Entergy Nuclear Operations, Inc.
Pilgrim Nuclear Power Station
600 Rocky Hill Road
Plymouth, MA 02360

SUBJECT: Entergy Nuclear Operations, Inc.
Pilgrim Nuclear Power Station
Docket No. 50-293
License No. DPR-35

Entergy Response to NRC Request for Additional Information dated January 10, 2011, to support the review of Setpoint and Setpoint Tolerance Increases for Safety Relief Valves (SRV) and Spring Safety valves (SSV) (TAC No. ME3543)

ENTERGY RESPONSE TO NRC REQUEST FOR ADDITIONAL INFORMATION (RAI) TO SUPPORT THE REVIEW OF SETPOINT AND SETPOINT TOLERANCE INCREASES FOR SAFETY RELIEF VALVES AND SPRING SAFETY VALVES, AND RELATED CHANGES (TAC No. ME3543)

Calculated Limits and Setpoint Relationship (Figure 2)

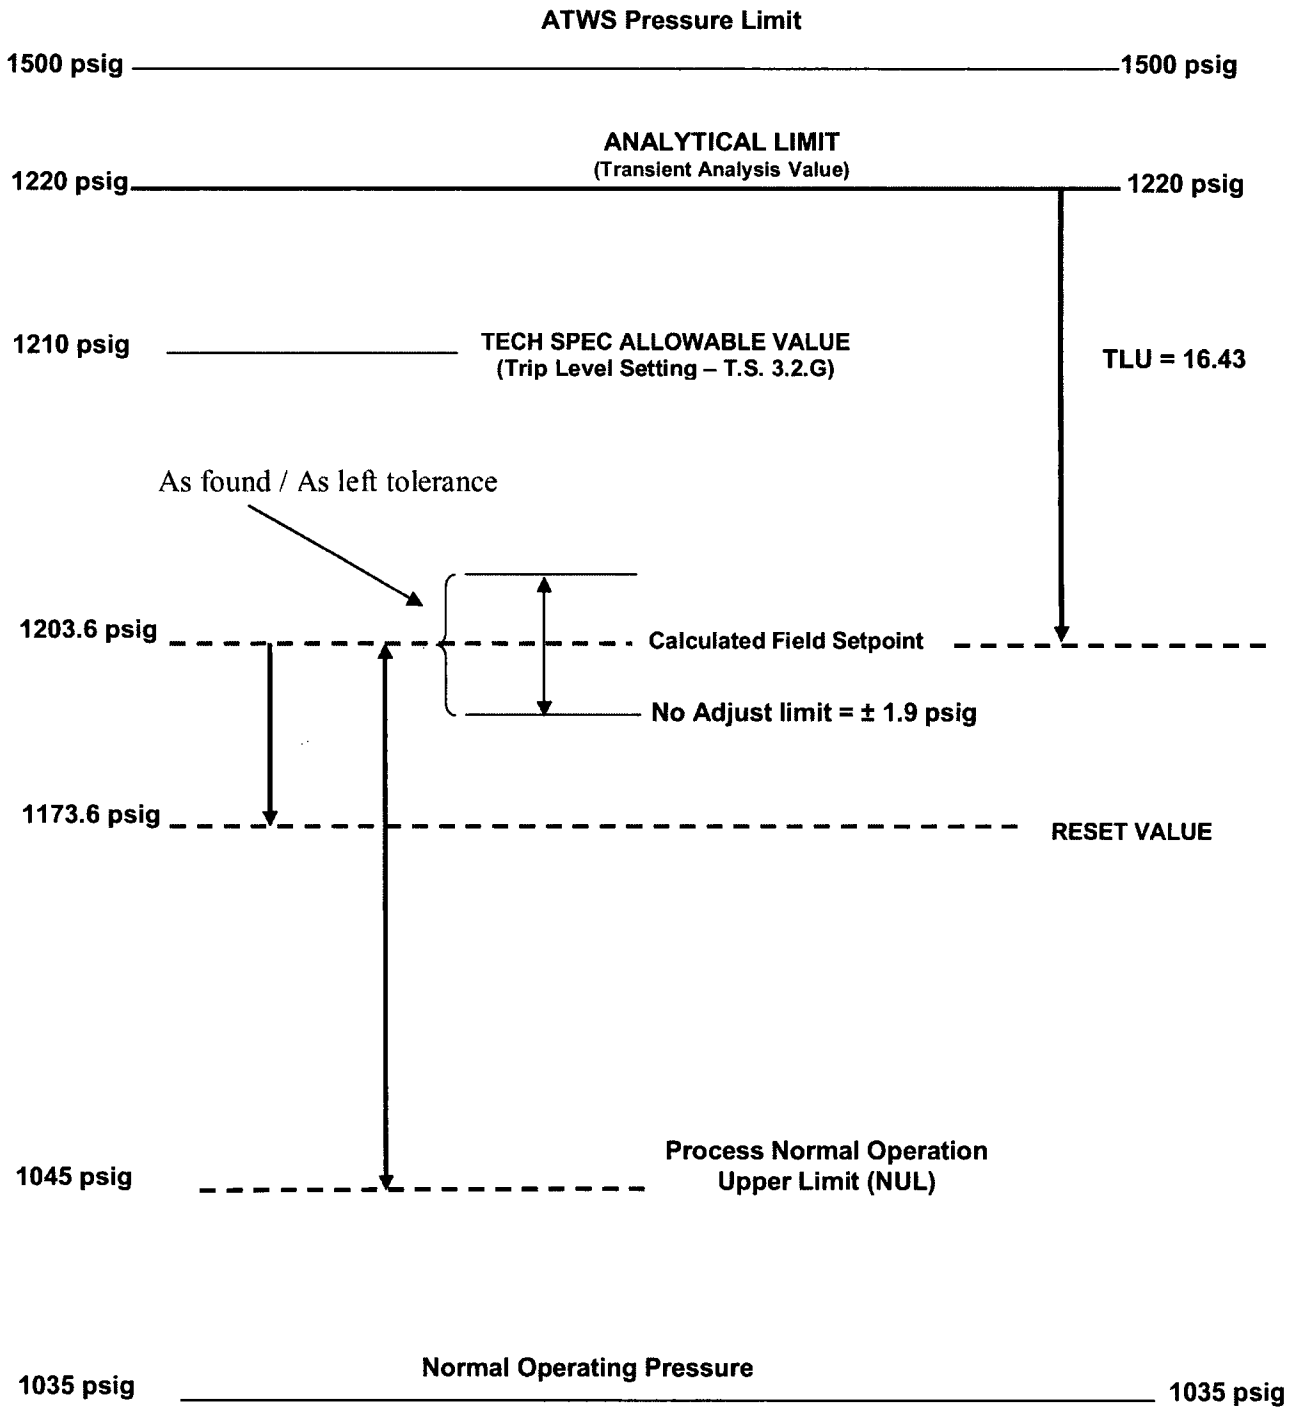
Clarify what the column title, "Trip Level Setting," in TS Table 3.2-G, "Instrumentation that initiate Recirculation Pump Trip and Alternate Rod Insertion," represents compared to the setpoint terms listed in Figure 1 of Regulatory Guide (RG) 1.105, "Setpoints for Safety-Related Instrumentation," Revision 3, dated December 3, 1999.

Provide documentation of the methodology used for establishing the limiting trip setpoint or normal trip setpoint and limiting acceptable values for the as-found and as-left setpoints as measured during the periodic surveillance testing. Documentation should:

The term "Trip Level Setting" in TS Table 3.2-G represents the Allowable Value (AV). The proposed value of ≤ 1210 psig is the Allowable Value, which is also the notify Shift Manager value. It is the limiting value that the instrument setpoint may have when tested periodically, beyond which appropriate action will be required (See Response to RAI 3). The instrument setpoint is 1203.6 ± 1.9 psig and represents the process value at which the switch is expected to change state. The difference between the two values represents the allowable value to trip setpoint margin. The difference between the two values represents errors associated with the as-found tolerance and drift.

The relationship of the field setpoint to the calculated limits is shown on Figure 2.
